ADDENDUM
MEETING OF THE PLANNING COMMITTEE
WEDNESDAY 27th MARCH 2024

**PLANNING APPLICATION: 23/00879/F SOUTH PARK SPORTS ASSOCIATION
WHITEHALL LANE REIGATE SURREY RH2 8LG**

**PLANNING APPLICATION: 21/02938/F - BOLTERS CORNER REST HOME
BOLTERS LANE BANSTEAD SURREY SM7 2AB**

PLANNING APPLICATION: 24/00118/F – 40-46 BRIGHTON ROAD, SALFORDS, SURREY

Client:
Bolters Nursing Home
Project:
Bolters Corner, Banstead
Description:
Landscape Strategy

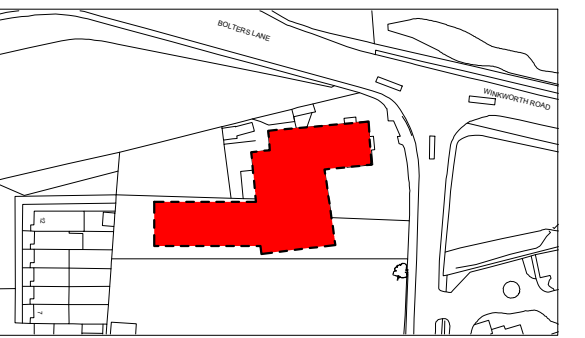
- Updated Biodiversity Net Gain Report – this has been updated to reflect the fact that the staff accommodation has been built (**Appendix A of addendum**). The report still shows a more than 10% increase in habitat units (now 19% rather than 15% and 100% creation of hedgerow units. Condition 12 is recommended to be amended to reflect the new document. It should also be noted that the BNG figure does not include the 8 additional trees proposed outside the red line boundary, which will further improve biodiversity.
- Updated Landscaping Strategy Plan – this has been updated to reflect the proposed site plan, showing the majority of the proposed trees along the southern boundary being planting within the red line. Condition 11 is

recommended to be amended to reflect the updated landscaping plan (**Appendix B of addendum**)

| Revision | Description | Date | By | Chk. |
|----------|--|----------|----|------|
| H | Planting in relation to red line updated | 27/3/24 | CB | SH |

File Number: **2255-IDL-NA-ZZ-DR-A-12001** (Rev. 1)

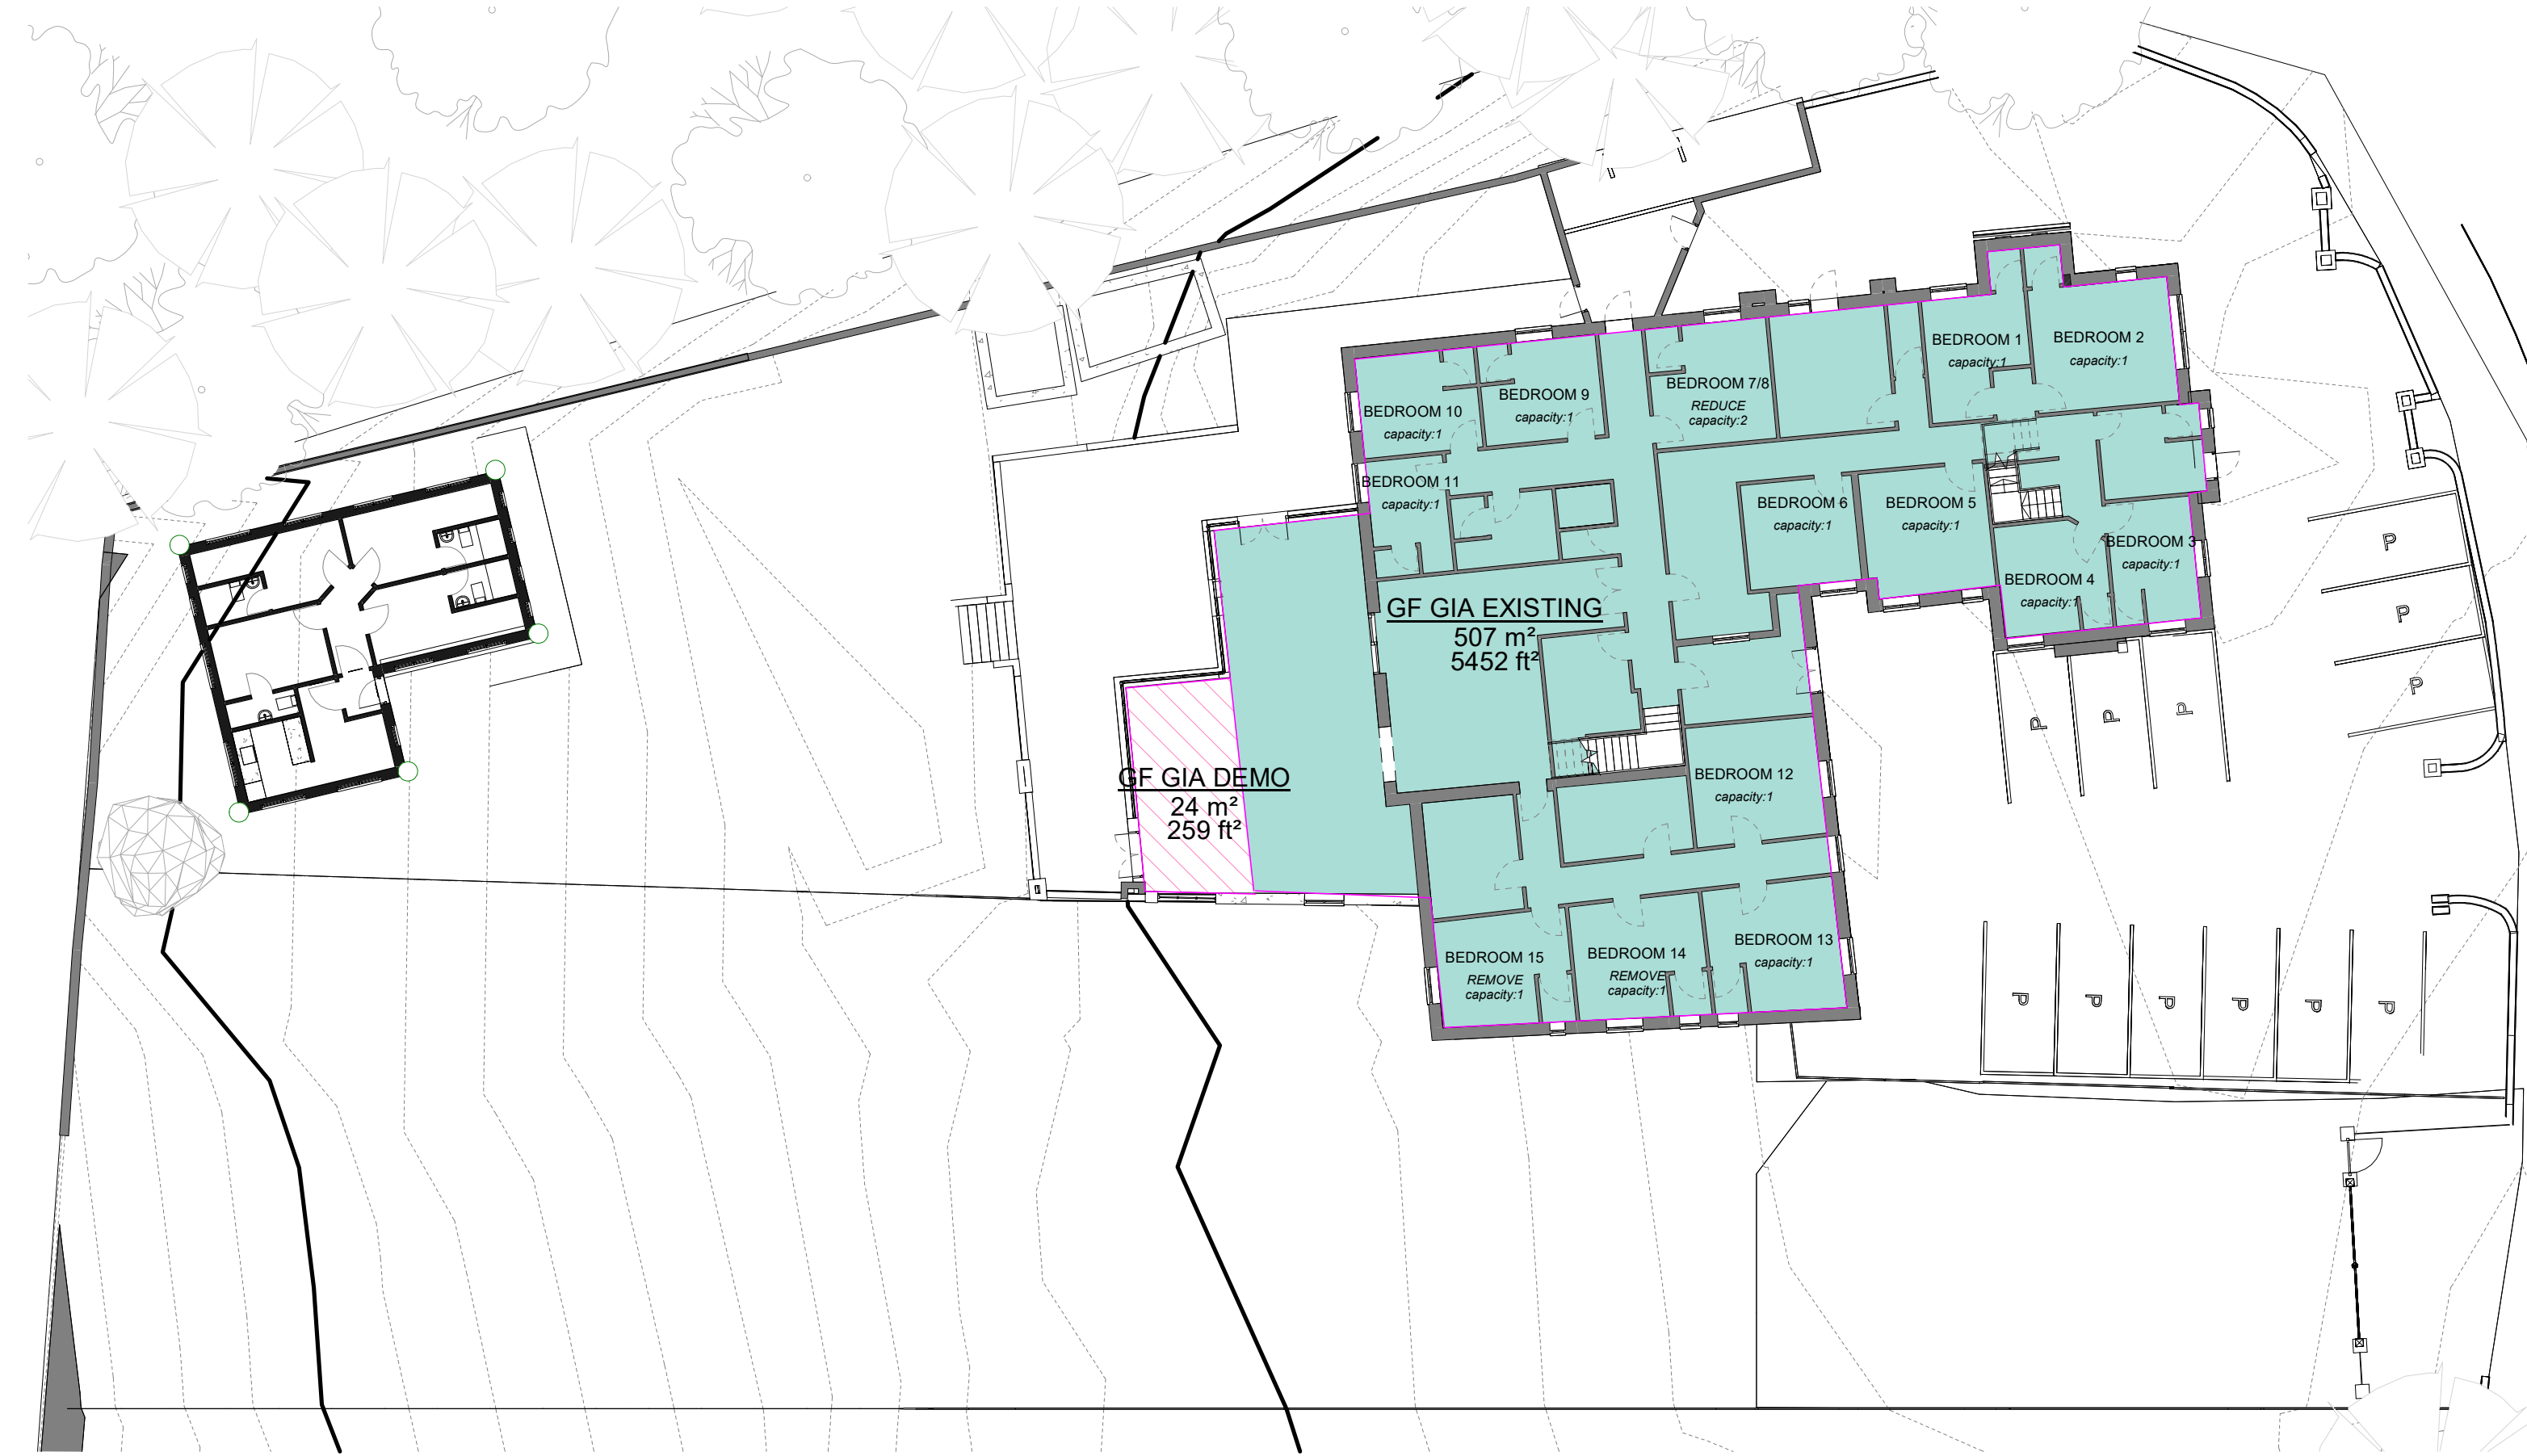
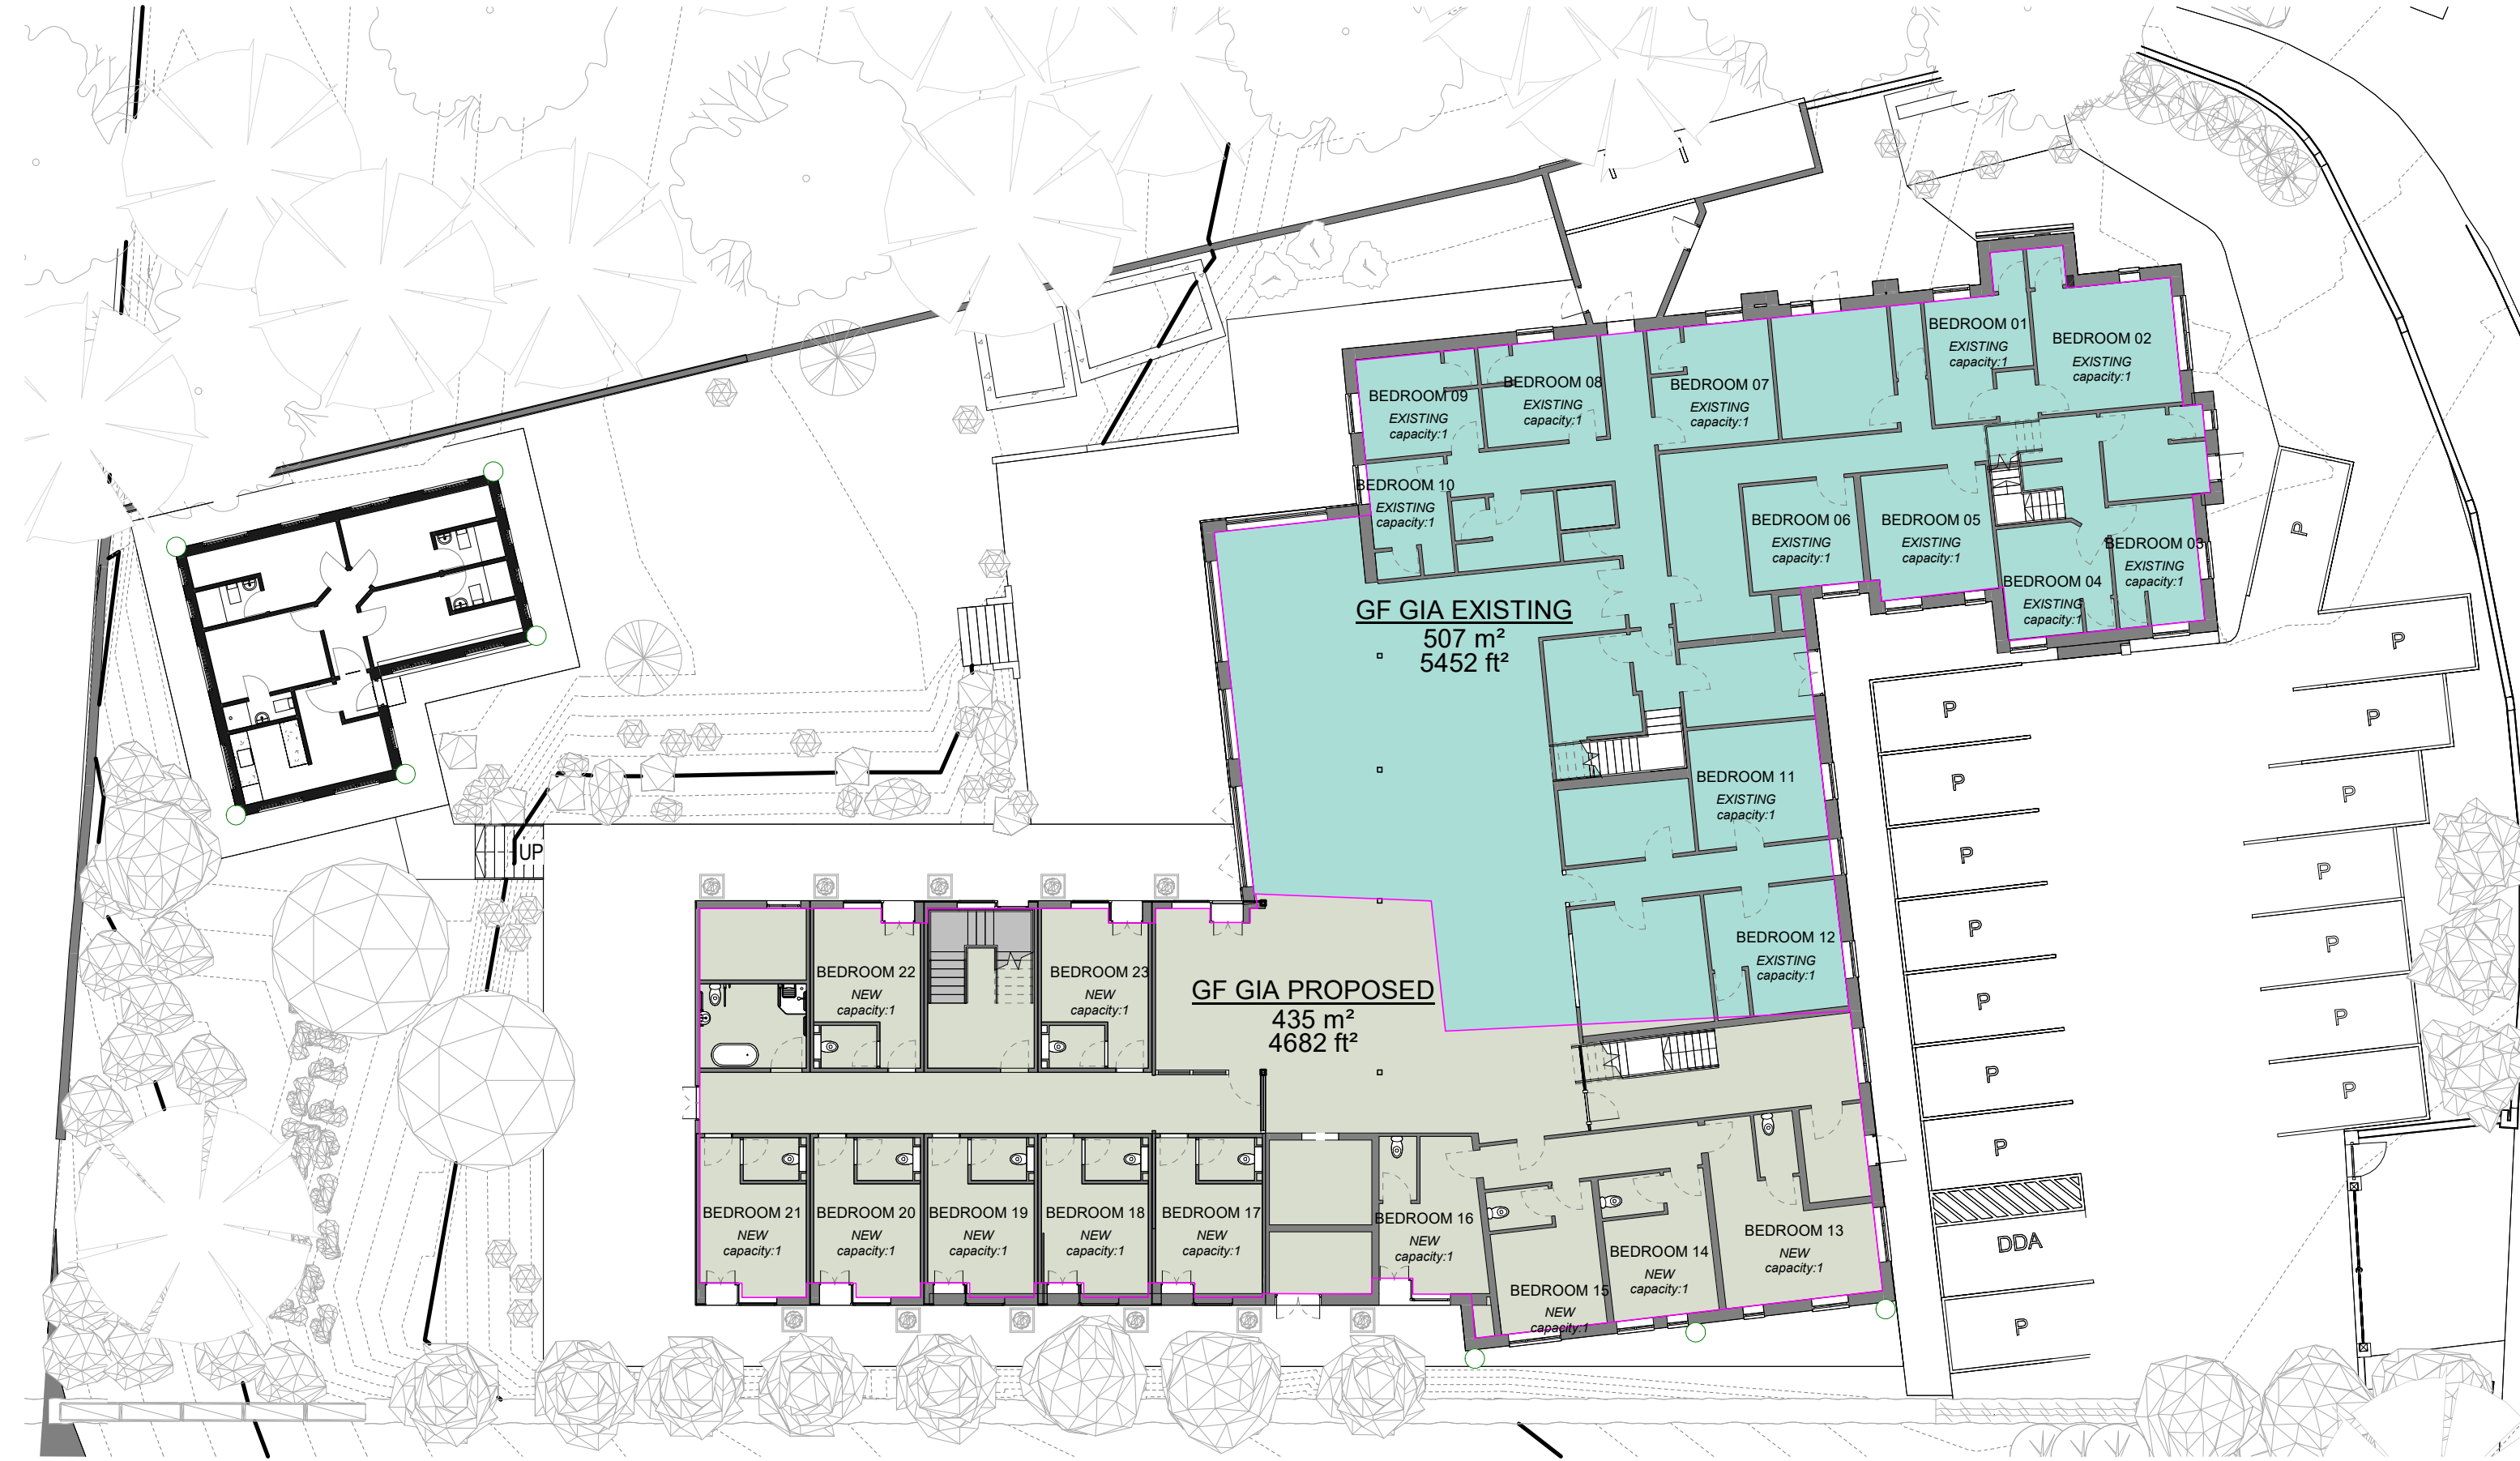
- Updated EXISTING & PROPOSED AREAS & BEDROOM SCHEDULES drawing, 2255-IDL-NA-ZZ-DR-A-12001 (**Appendix C of addendum**)

| 3.11 180324/REVISED PLANNING | HWSG |
